RESOLUTION SETTING HEARING REGARDING REQUEST FROM ELECTRO MANAGEMENT CORP (OWNER), REPRESENTED BY BRITT BAKER (OFFICER), FOR REVIEW AND APPROVAL OF A 2ND AMENDMENT TO THE CITY GATEWAY PUD CONCEPTUAL PLAN, ON TWO PARCELS LOCATED IN THE VICINITY OF 4240 ARMY POST ROAD, TO ALLOW THE CONSTRUCTION OF NEW WAREHOUSE SPACES, AND TWO PARKING LOTS

Communication from the City Plan and Zoning Commission advising that at their September 7, 2023 meeting, the following action was taken regarding a request from Electro Management Corp (owner), represented by Britt Baker (officer) for review and approval of a 2nd amendment to the City Gateway PUD Conceptual Plan on two parcels located in the vicinity of 4240 Army Post Road, to allow the construction of new warehouse spaces, and two parking lots.

SECOND AMENDMENT CITY GATEWAY PUD CONCEPTUAL PLAN ELECTRO MANAGEMENT CORP.

CITY GATEWAY PUD CONCEPTUAL PLAN
DES MOINES, IA
LAYOUT PLAN

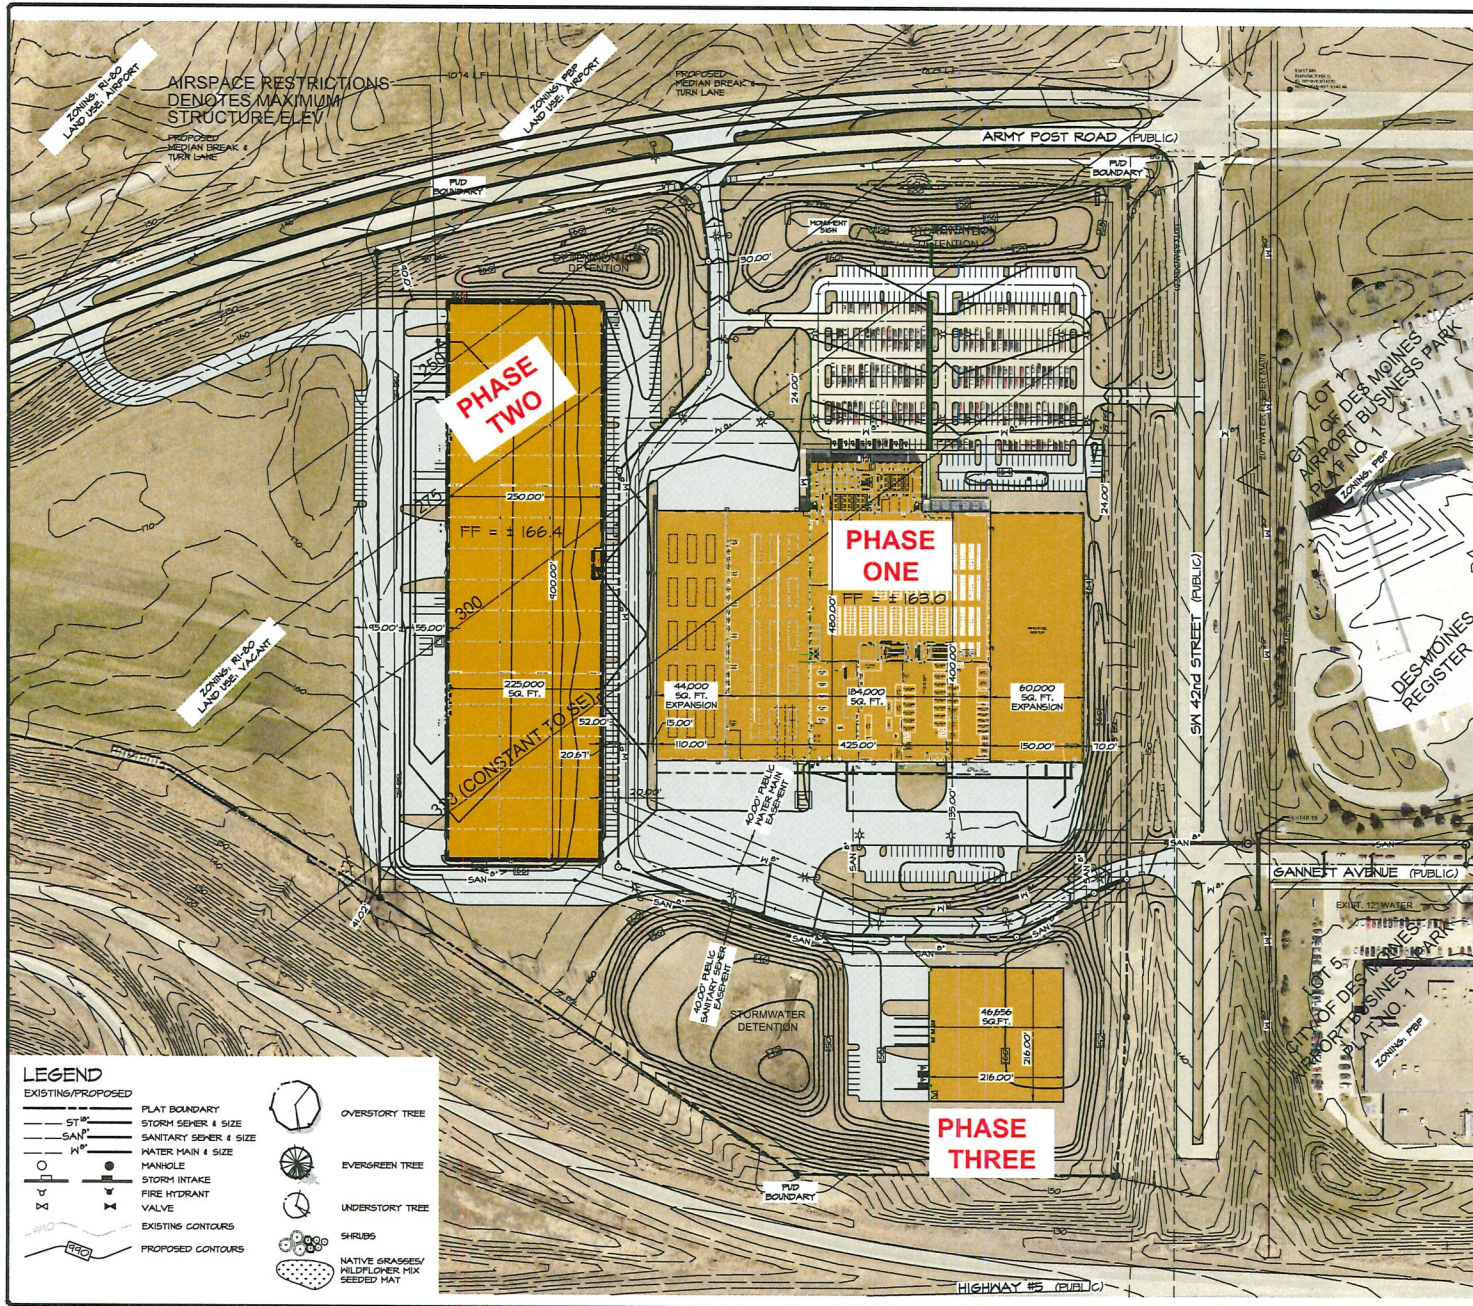
3. Any proposed full access drive entrances from Army Post Road in addition to the existing driveway shall be shared with the undeveloped City Gateway 2 “PUD” property to the west.

4. Should any driveway from Army Post Road be developed as full access it should be shown and developed with a westbound left turn-in lane constructed in the median and an eastbound right turn-in lane in the Right-of-Way west of the drive entrance, all at the expense of the developer and in accordance with SUDAS requirements.

3. Any proposed full access drive entrances from Army Post Road in addition to the existing driveway shall be shared with the undeveloped City Gateway 2 "PUD" property to the west.

4. Should any driveway from Army Post Road be developed as full access it should be shown and developed with a westbound left turn-in lane constructed in the median and an eastbound right turn-in lane in the Right-of-Way west of the drive entrance, all at the expense of the developer and in accordance with SUDAS requirements.

3. **Traffic/Street System:** The proposed amendment to the PUD Conceptual Plan indicates a second full movement access from Army Post Road. There is an existing full movement driveway that provides access into the site from Army Post Road. The First Amendment to the PUD was approved subject to the condition that only one drive entrance from Army Post may be allowed with full access. Staff believes that while a full drive access to this development is not necessary, the proposed second driveway can provide shared access to the undeveloped parcel to the west, if and when it develops as well as the warehouse expansion in Phase 2. Traffic and Transportation staff have indicated that a second full movement driveway can be considered if the applicant can ensure that the proposed second full movement driveway will provide shared access to the parcel to the west in addition to the proposed warehouse in Phase 2.
